**Rezoning Application:** PD 24-0031  
**Zoning Hearing Master Date:** March 25, 2024  
**BOCC Land Use Meeting Date:** May 7, 2024

**Hillsborough  
County Florida**

Development Services Department

## AGENCY REVIEW COMMENT SHEET

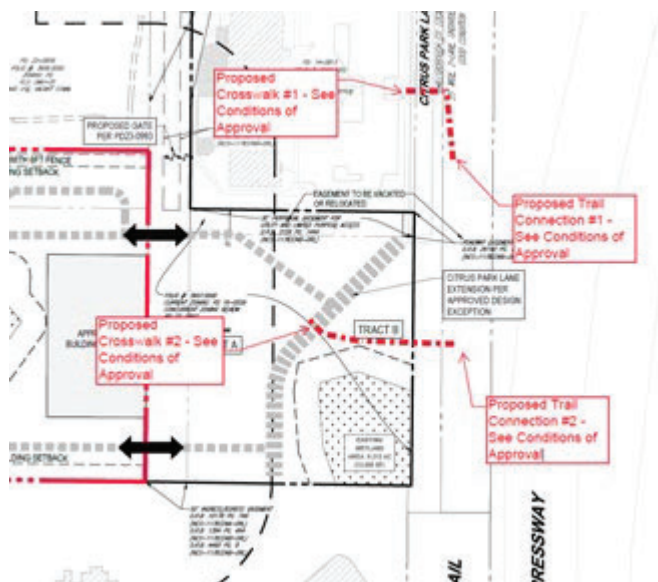
- a. Modify Site Note 10 to add the statement "The emergency access connection shall be gated with a Knox Box or similar device acceptable to the Hillsborough County Fire Marshall."

- b. Modify Site Note 11 to delete the statement "...and cross access to adjacent properties...". Staff is unaware of any proposed cross access, only one (1) vehicular and pedestrian connection to the Citrus Park Ln. Ext. and one (1) pedestrian and gated emergency access to Meadowview Cir.

- c. Add the location of required ADA-compliant trail connections and crosswalks as shown below. Label the two connections as follows: "Proposed Crosswalk #1 – See Conditions of Approval", "Proposed Trail Connection #1 – See Conditions of Approval", "Proposed Crosswalk #2 – See Conditions of Approval", and "Proposed Trail Connection #2 – See Conditions of Approval". Also, show and label the areas designated Tract A and Tract B within PD 23-0993.

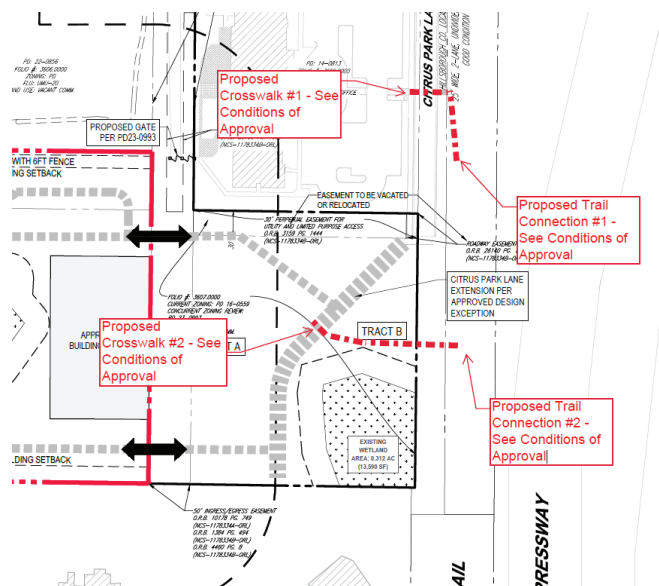
- Prior to PD Site Plan Certification, the developer shall revise the PD Option 2 site plan to:
  - Modify Site Note 10 to add the statement “The emergency access connection shall be gated with a Knox Box or similar device acceptable to the Hillsborough County Fire Marshall.”

- Modify Site Note 11 to delete the statement “...and cross access to adjacent properties...”. Staff is unaware of any proposed cross access, only one (1) vehicular and pedestrian connection to the Citrus Park Ln. Ext. and one (1) pedestrian and gated emergency access to Meadowview Cir.

- Add location of required ADA compliant trail connections and crosswalks as shown below. Label the two connections as follows: “Proposed Crosswalk #1 – See Conditions of Approval”, “Proposed Trail Connection #1 – See Conditions of Approval”, “Proposed Crosswalk #2 – See Conditions of Approval”, and “Proposed Trail Connection #2 – See Conditions of Approval”. Also, show and label the areas designated Tract A and Tract B within PD 23-0993.

**FIGURE 1**

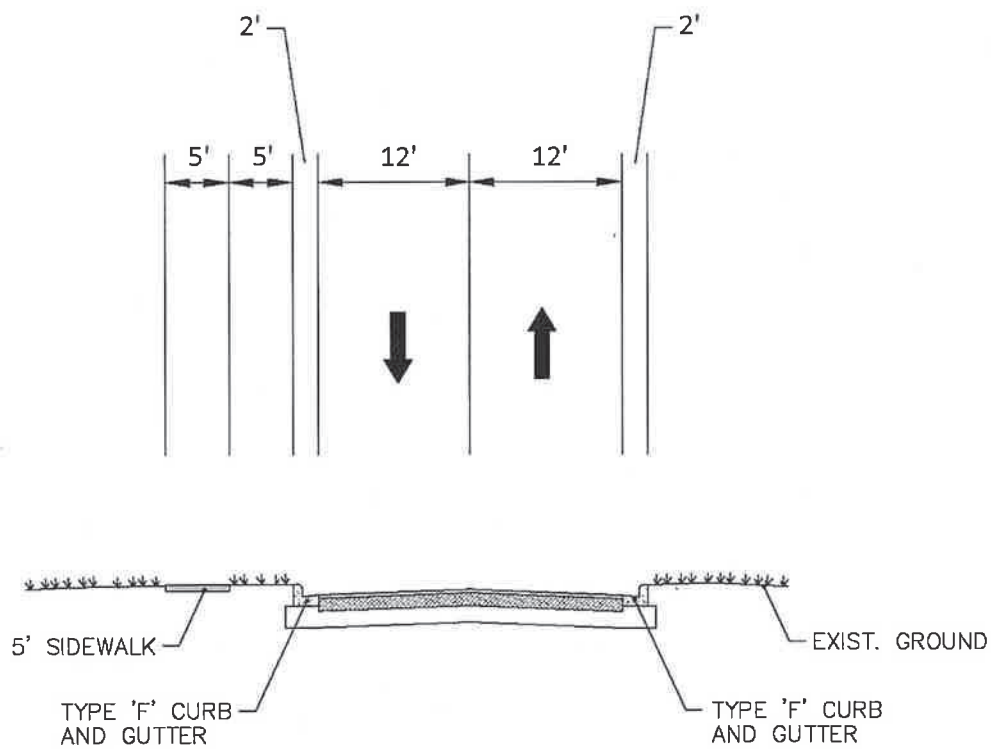
Figure 1 illustrates the proposed typical section for the extension of Citrus Park Lane from the current terminus to PD 24-0031. The deviations and justifications for the variance to TS-4 are as follows:

FIGURE 2  
PROPOSED TRAIL CONNECTION

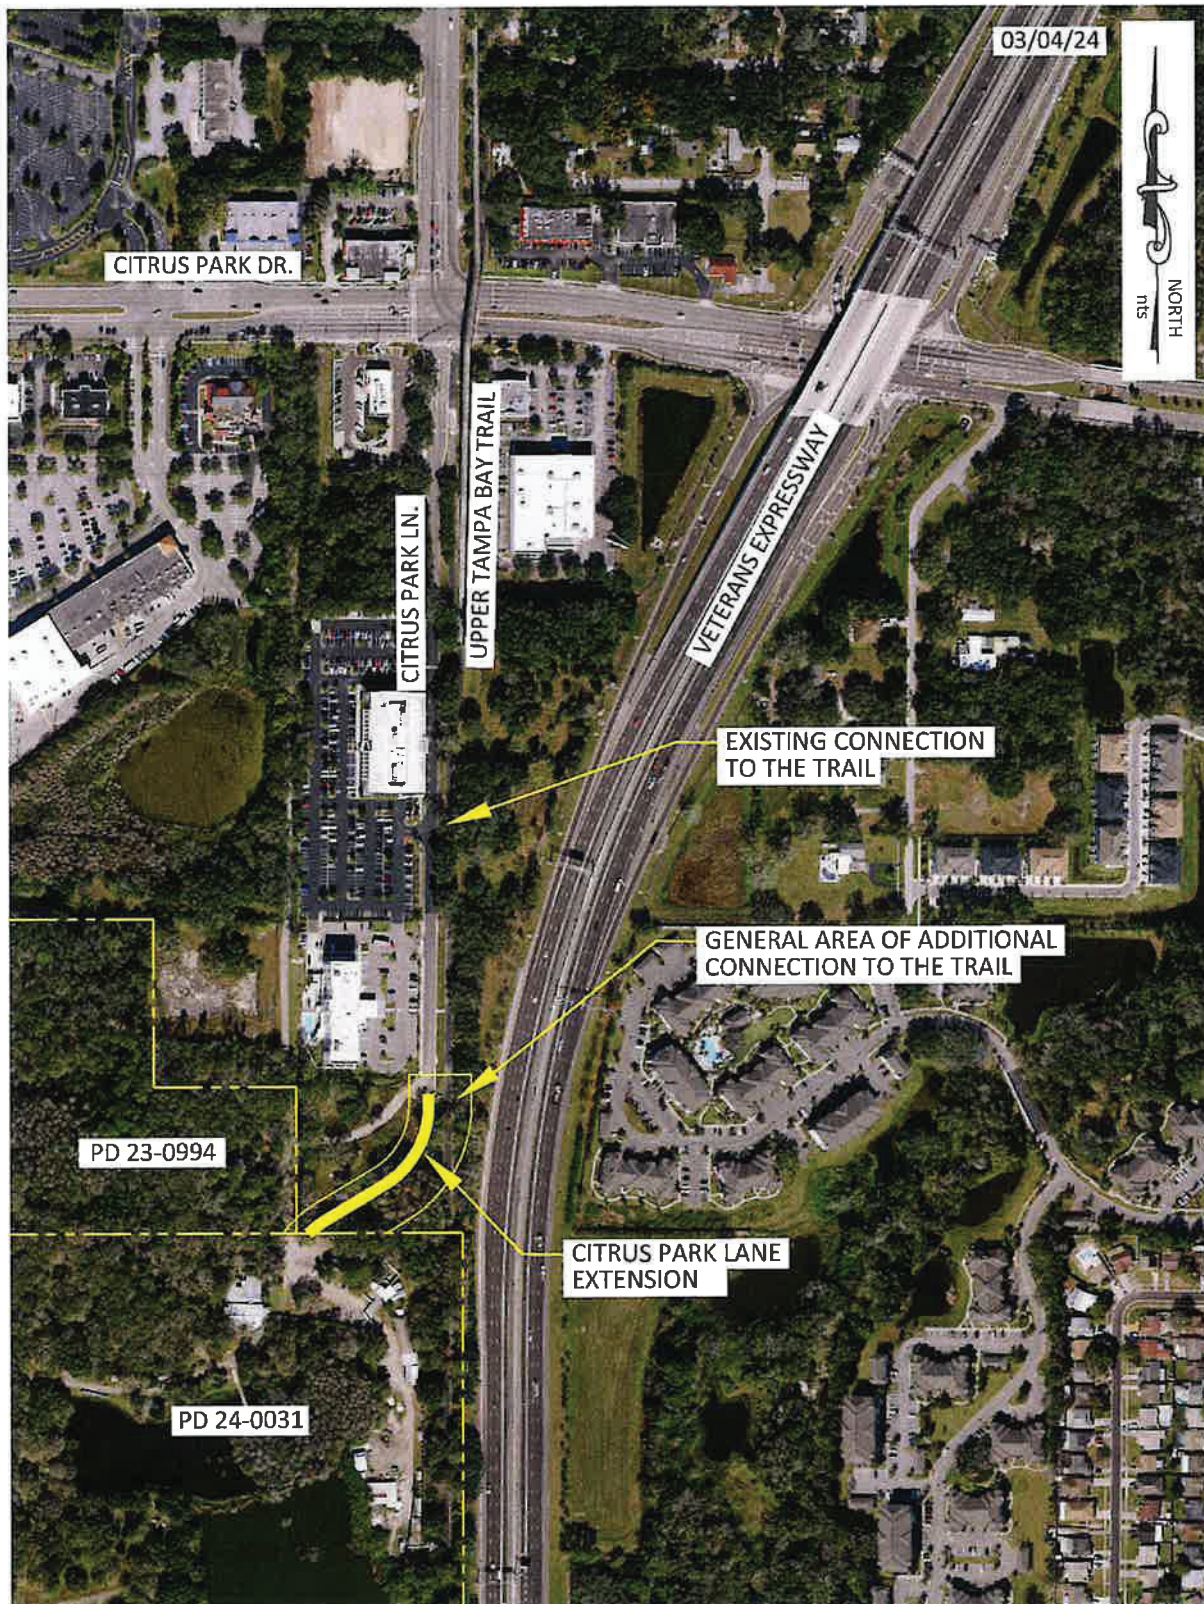
In addition, as mitigated for the substandard road, the developer proposes to provide an additional connection to the ~~Suncoast Trail~~ that is proposed to meet ADA criteria. The final location and design is to be provided at the design stage of the project and approved by the Hillsborough County Conservation and Environmental Lands Management Department. Figure 2 illustrates the general area of the connection.

FIGURE 1  
Intersection Improvements

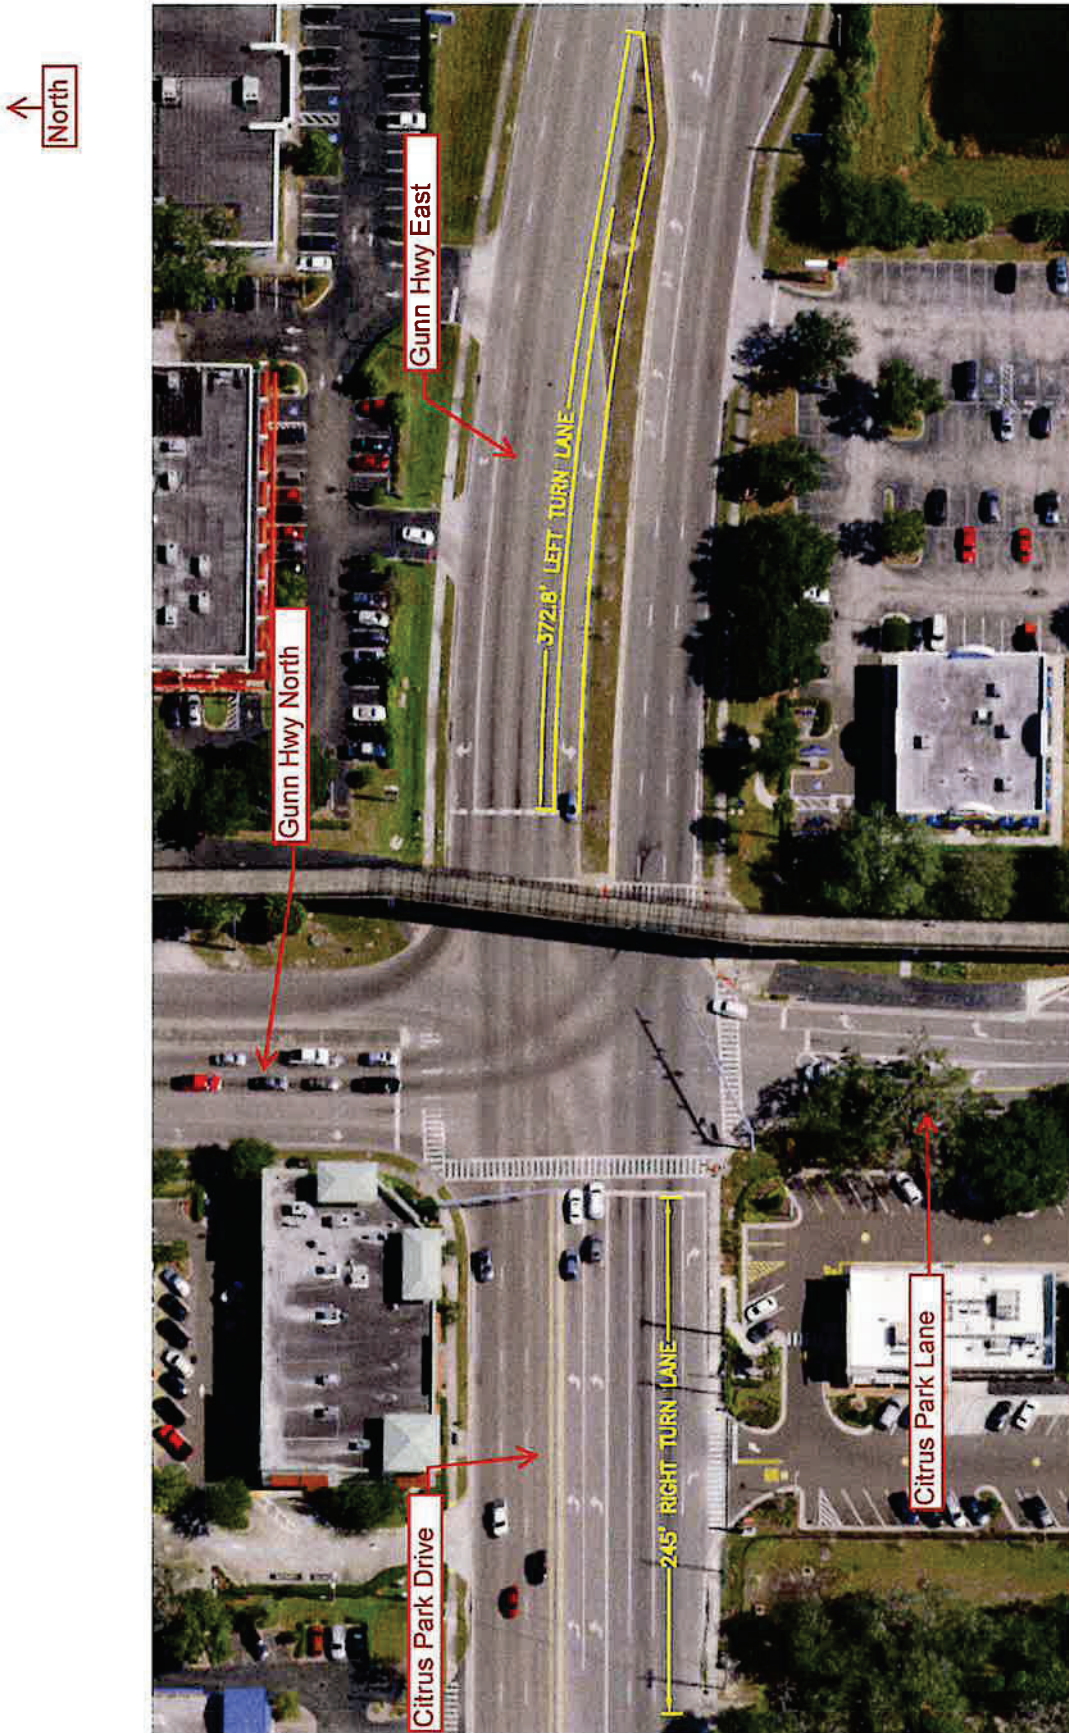
The existing westbound left turn lane is approximately 230 feet. In conjunction with the rezoning of these properties, the developers propose to extend the existing turn lane to approximately 372 feet, as shown in Figure 1.

As shown in Figure 1, the westbound left turn lane can be extended to approximately 372 feet which accommodates the 95<sup>th</sup> percentile queue for both scenarios. The turn lane can not be extended due to the eastbound left turn lanes for the Veterans Expressway Ramps.
